Subsequent to PIC #6, refinements have been made to the Recommended Plan in response to stakeholder comments and input received through the PIC #6 consultation process and further development of the preliminary design. Key refinements are described below. The Final Recommended Plan, with the below noted refinements incorporated, will be available in the Transportation Environmental Study Report for public review.

Refinement to Recommended Plan

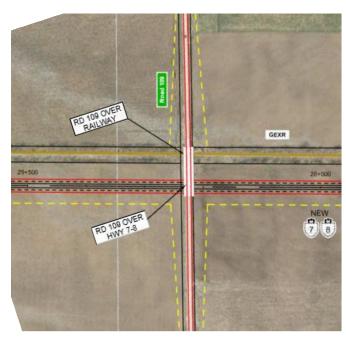
Highway 7&8 alignment east of Shakespeare and connection between existing Highway 7&8 and New Highway 7&8:

The Highway 7&8 alignment east of Shakespeare has been refined to allow for the provision of a full moves intersection between existing Highway 7&8 and New Highway 7&8 west of Road 106 / east of Shakespeare, addressing emergency response concerns and providing improved access to / from Shakespeare.
